Final Implementation Document
for the Interim Response Action for
Building 1727 Sump
at the Rocky Mountain Arsenal

COMMENTS ON THE DRAFT IMPLEMENTATION DOCUMENT
FOR THE INTERIM RESPONSE ACTION FOR THE
1727 SUMP

RESPONSE TO U.S. EPA REVIEW COMMENTS ON
THE DRAFT IMPLEMENTATION DOCUMENT FOR THE
INTERIM RESPONSE ACTION FOR BUILDING 1727 SUMP

FIGURE 4-2
TREATMENT DRUM

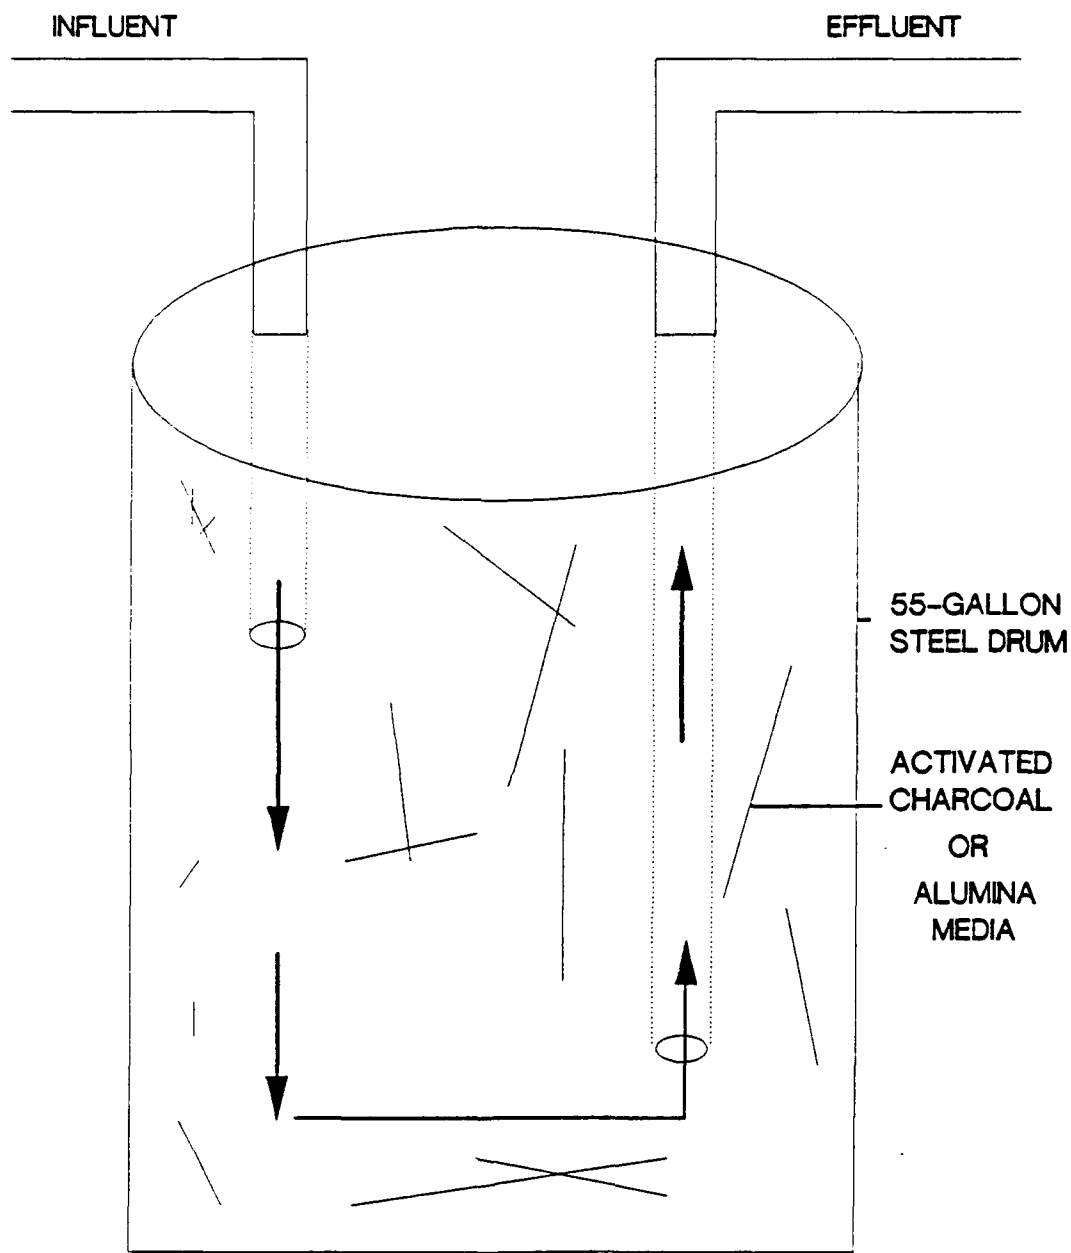
4. Page 23, Section 6.5. How long will the spent adsorbent disposal drums be stored in Buildings 1713 or 758? What will be the ultimate fate of the spent AA and spent GAC material? Refer to Comment 2 above: the storage, handling, and disposal of

Response: Concur. Section 6.5 has been revised to address this approach. The system is designed with a modular approach of using both GAC and AA drums that will be procured and disposed of in the filled condition. The GAC and AA drums will not be emptied of filter material and refilled during

Response: As noted in response to Specific Comment 3 above, the plan is to use the modular approach which will minimize storage time in the plant and will not require storage on-post. Spent drums will be returned to the vendor when new fresh drums are delivered.
